Model	AD1	Volt/Hz	Date of Modification	Serial Number
Modified Article		No serial Number cut-in information		
Reason for Modification	Parts catalog correction

The following should be corrected. Please correct your part catalog.

Fig. 1

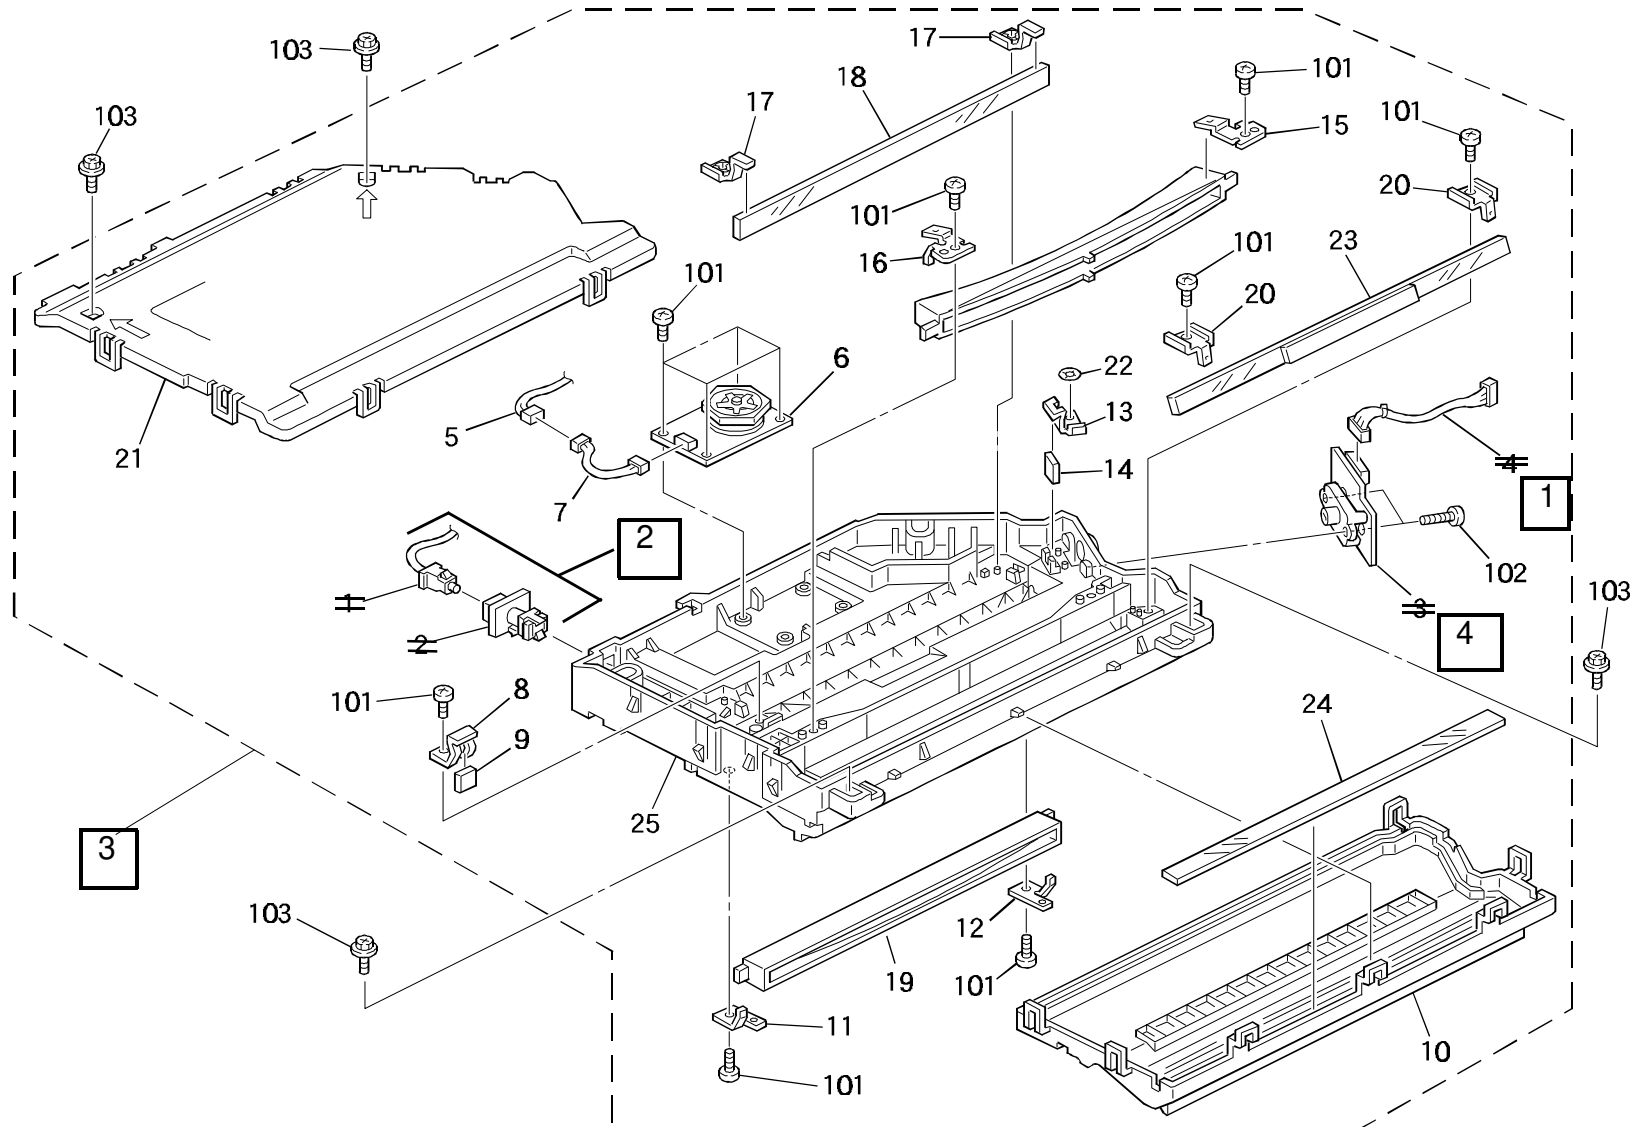
6. The index numbers in the illustration have been changed as follows. (SECTION 11. LASER UNIT)

Fig. 2

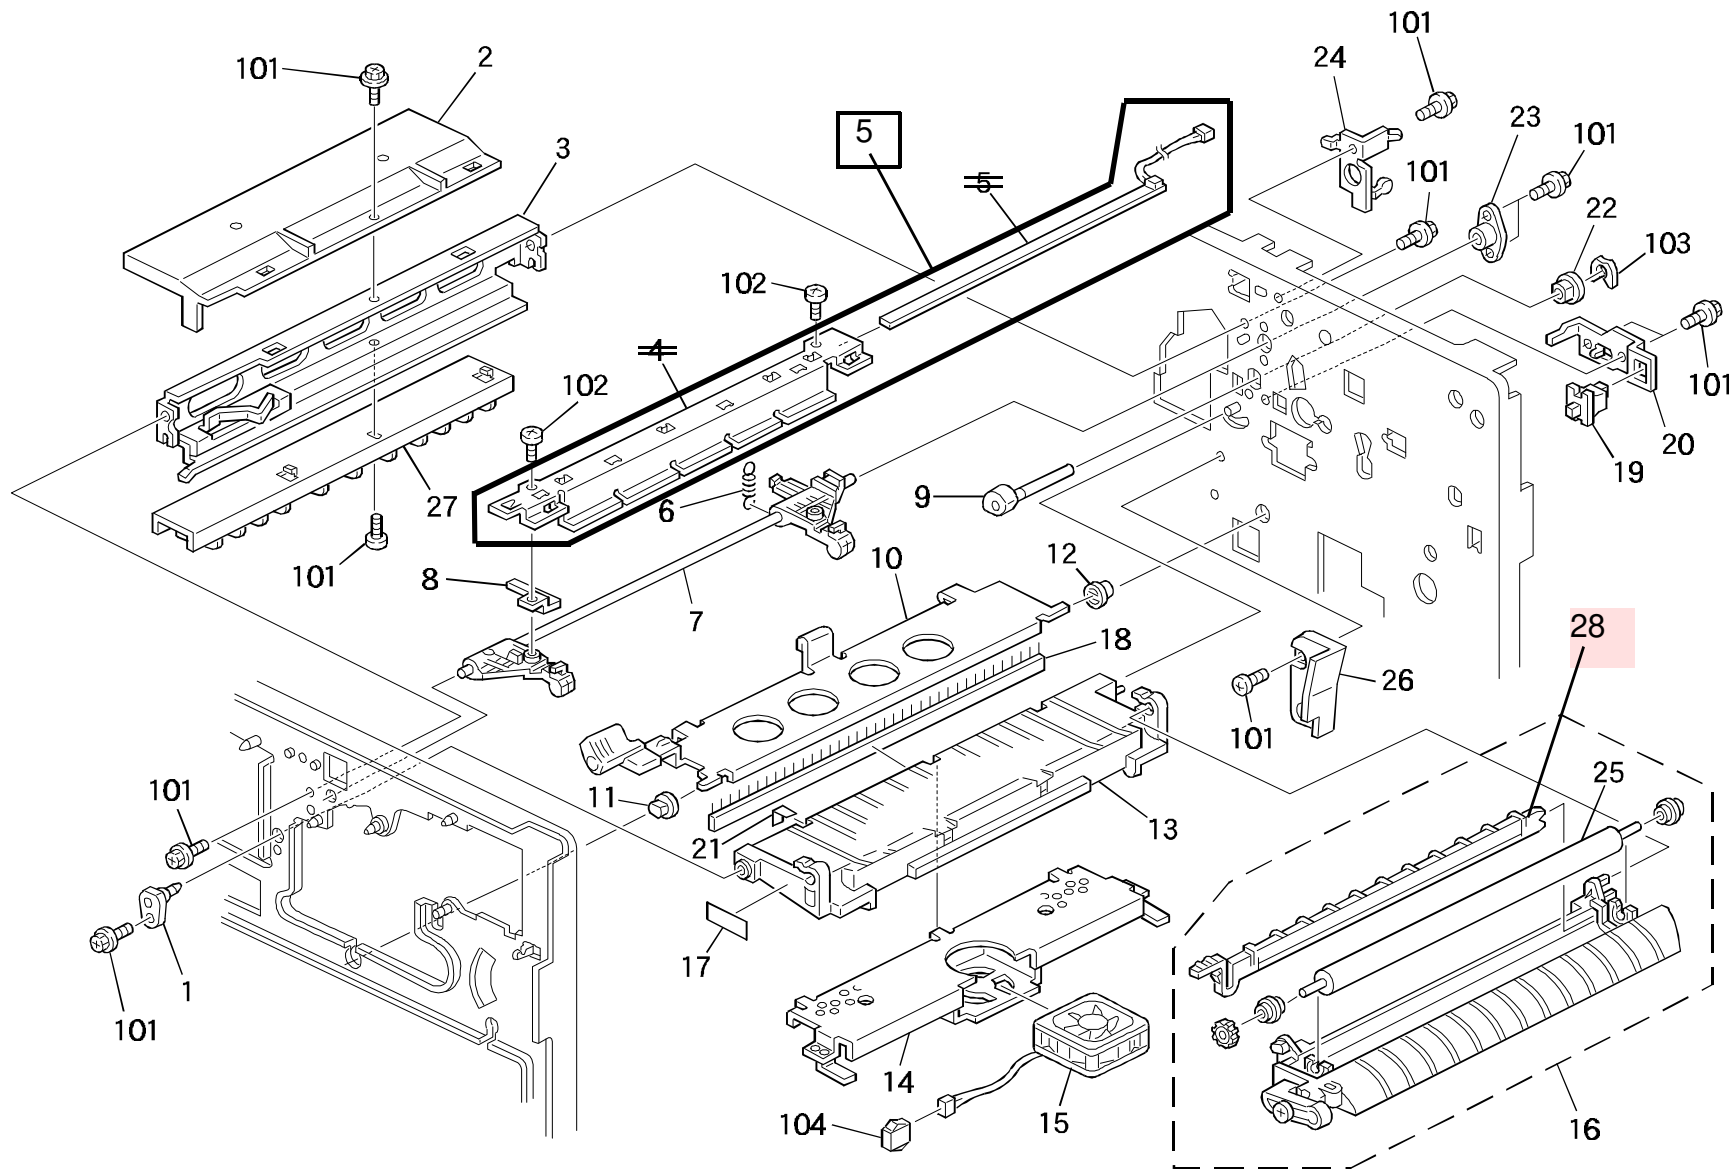
Old Part Number	New Part Number	Description	Q'ty	Index No.	Page	Fig. no.
G0202105		Bracket - Quenching Lamp	1	4	35	Fig.2
G0202104		Quenching Lamp	1	5	35	
	→ G0202104	Quenching Lamp Ass'y	1	5	35	
G0204411		Paper Exit Pawl	1	12	39	Fig.3
	→ G0204454	Paper Exit Pawl	1	12	39	
	→ G0204455	Spring	1	39	39

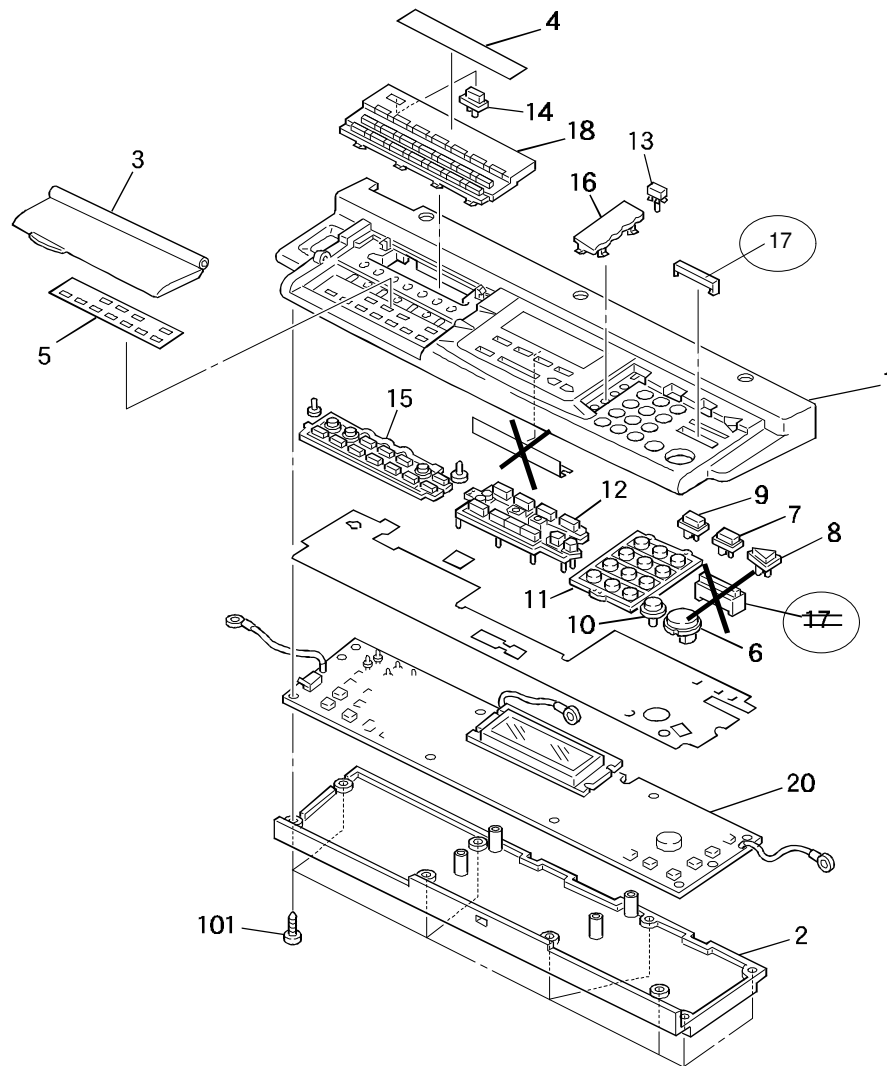
1. The following part has been deleted and the illustration has been changed (refer to the attached illustration).

Old Part Number	New Part Number	Description	Q'ty	Index No.	Page
A1941483		Key Top - LCD	1	21	13

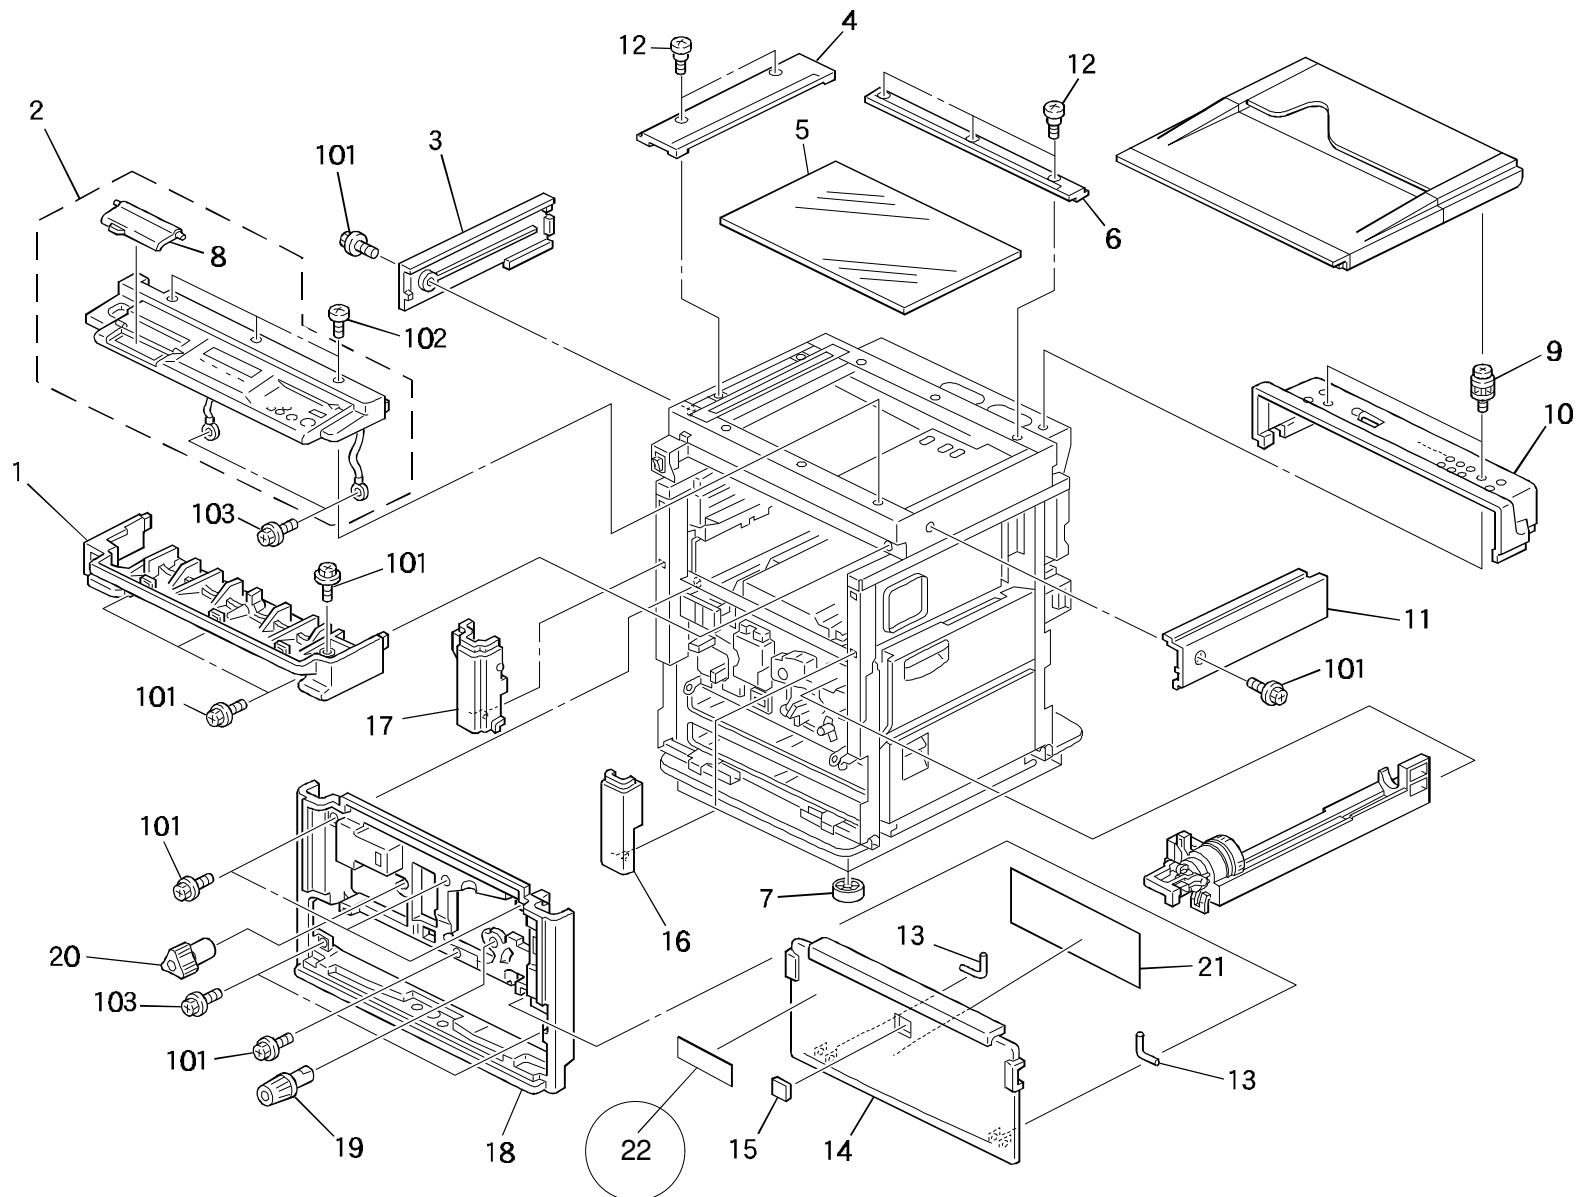
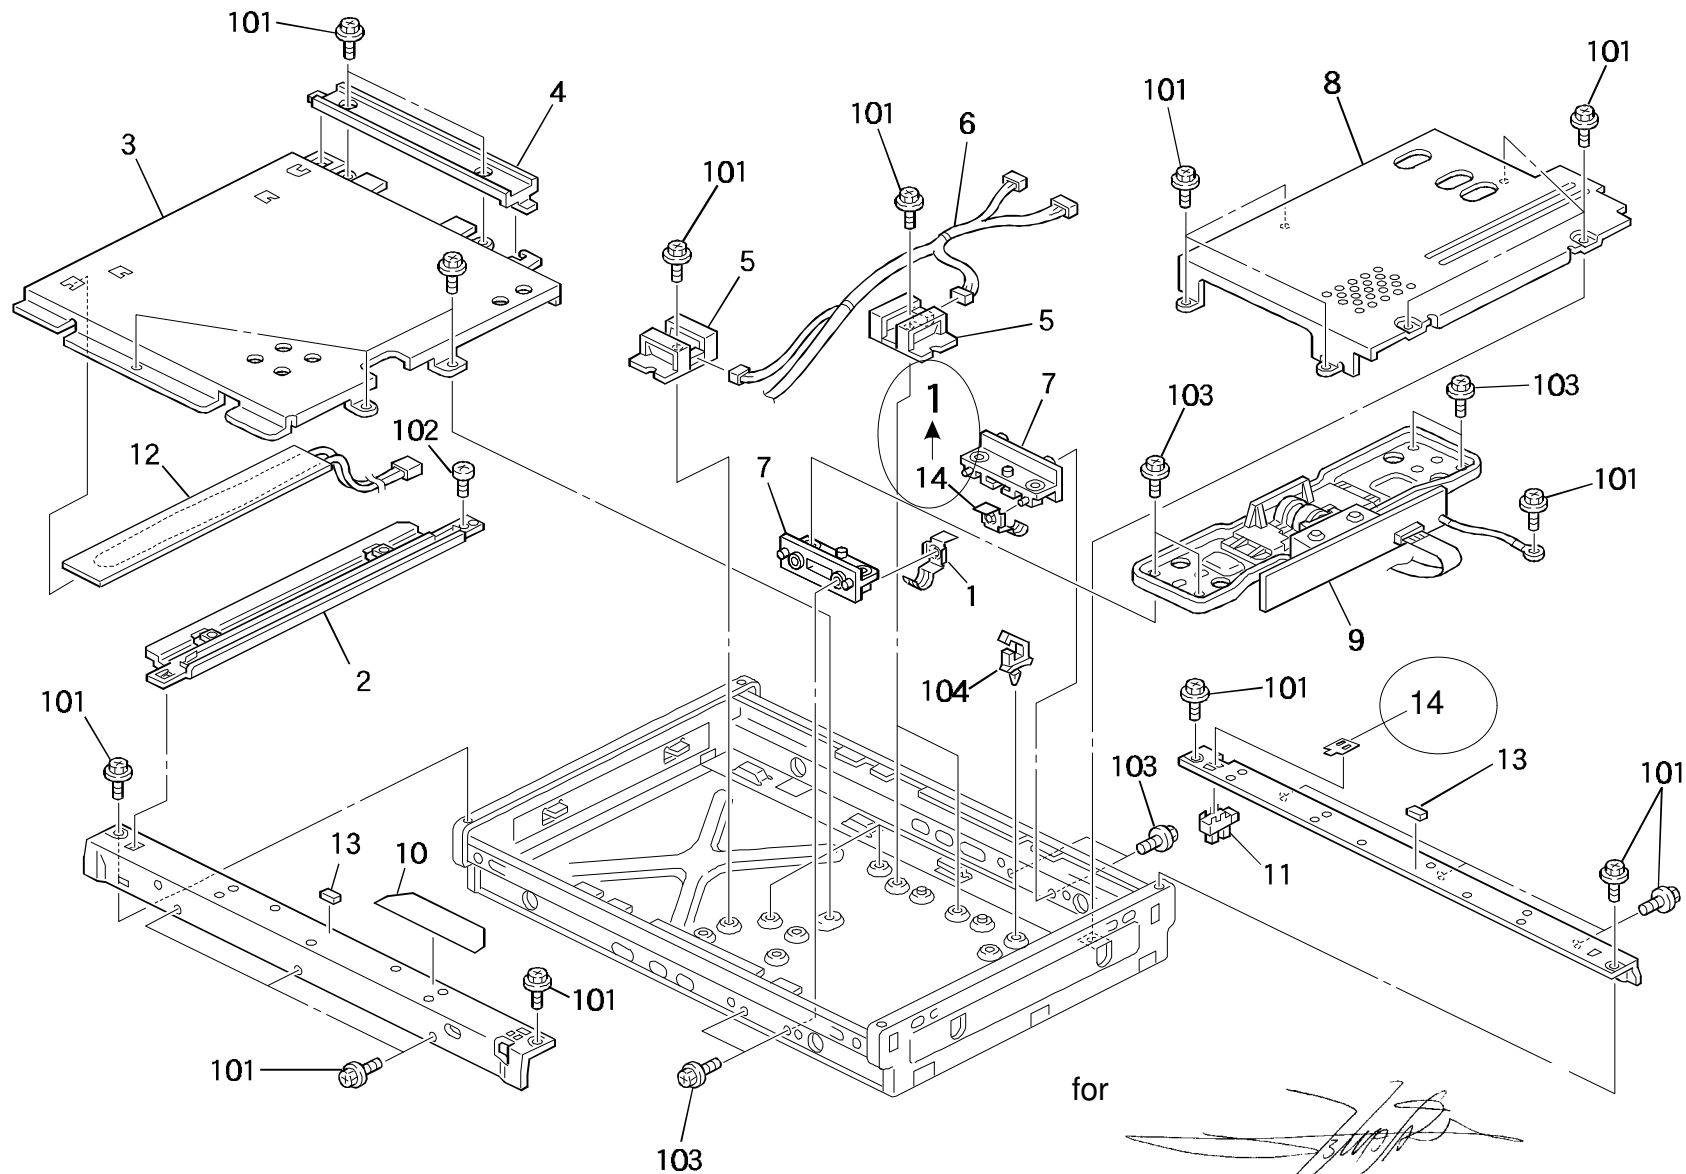
1. The following part has been added and the illustration has been changed (refer to the attached illustrations).

2. The index number of the illustration for section 9 (Optics Section 1) has been modified as follows.

Wrong index No. 14 → Correct index No. 1

3. The index number 24 of section 10 (Optics Section 2) is in the illustration, but not in the list . So, the following part has been added.

New

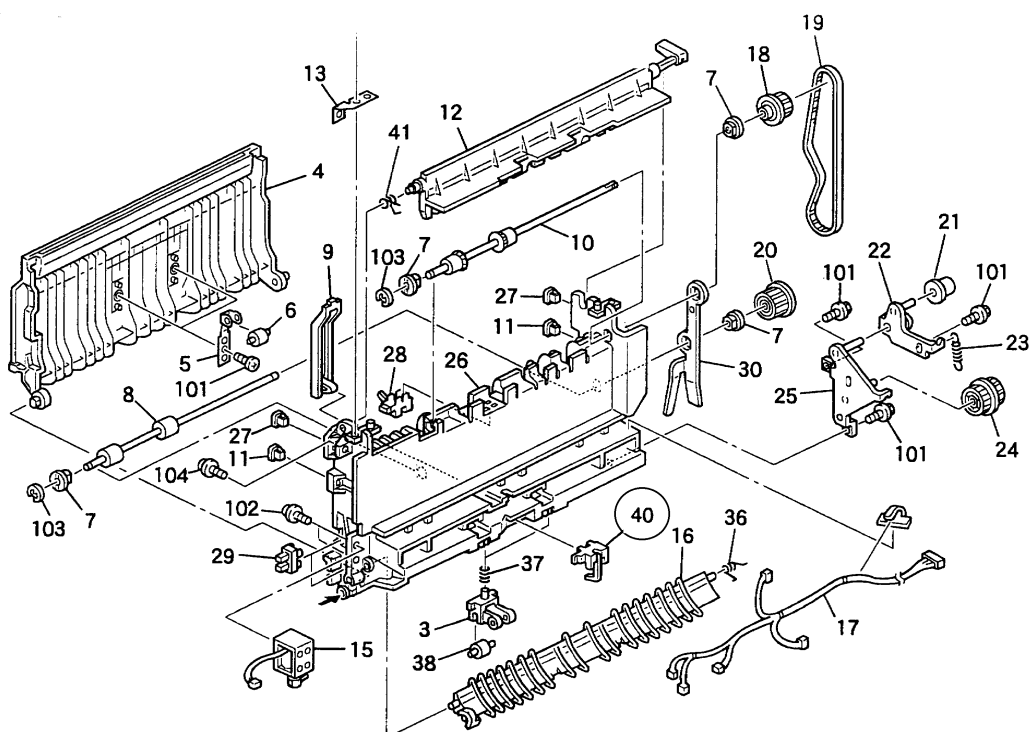
To prevent the paper exit sensors from being removed while pulling out jammed paper in the fusing unit, the shape has been changed.

Old part number	New part number	Description	Qty	Int	Page	Index	Note
G0204429	G0204472	Paper Exit Sensor	<i>2-1</i>		38	<i>40</i>	
G0204490	G0204472	Paper Exit Sensor	1-1		36	16

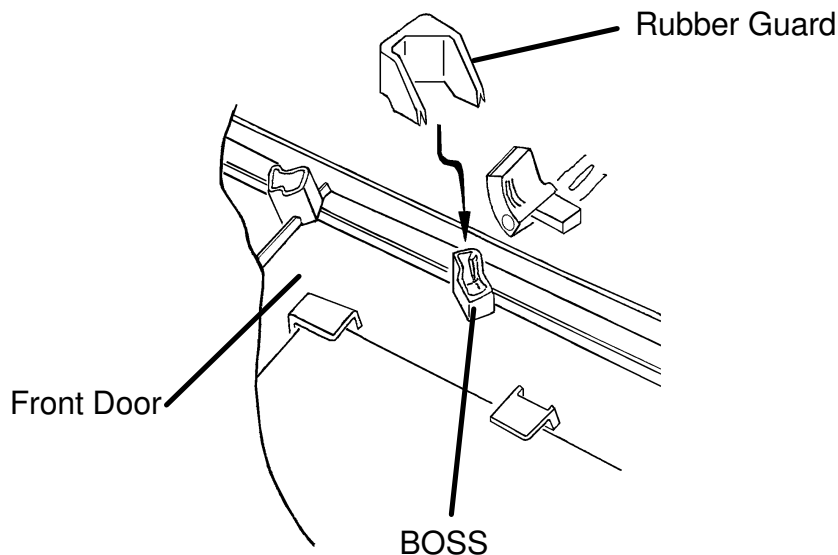
A Rubber Guard has been added on the boss on the front door to prevent the operator from injuring a finger.

Old part number	New part number	Description	Qty	Int	Page	Index	Note
	G0201259	Rubber Guard	0 - 1		6

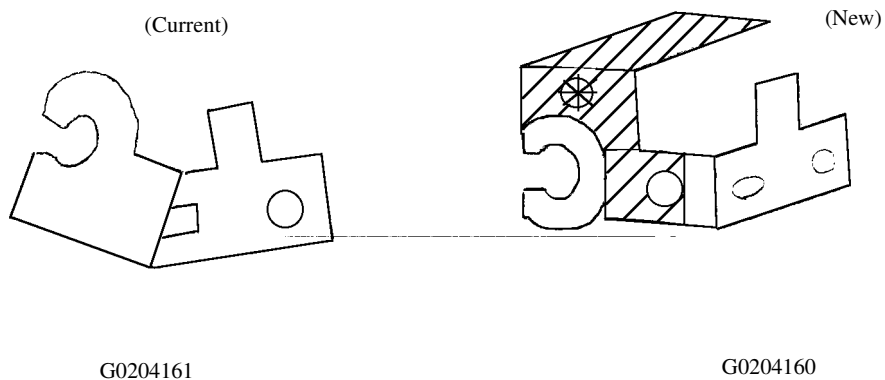
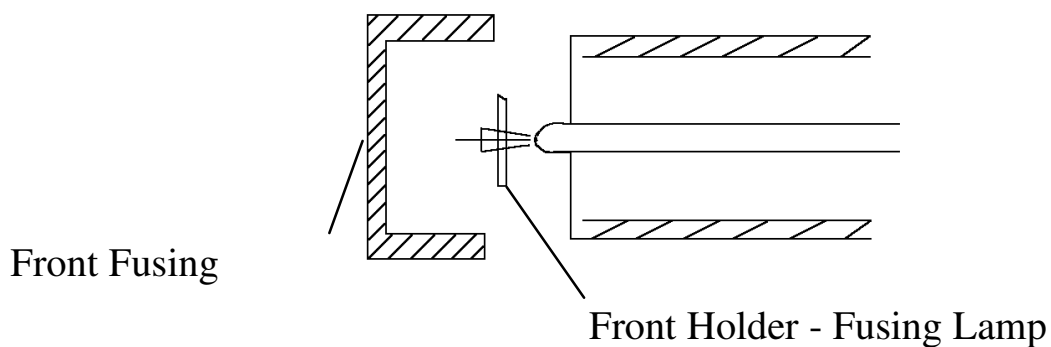
To prevent the Front Fusing Cover from becoming hot, the Front Holder-Fusing Lamp has a shield plate from December production '96.

Old part number	New part number	Description	Qty	Int	Page	Index	Note
G0204161	G0204160	Front Holder-Fusing Lamp	1-1	x/o	32	27
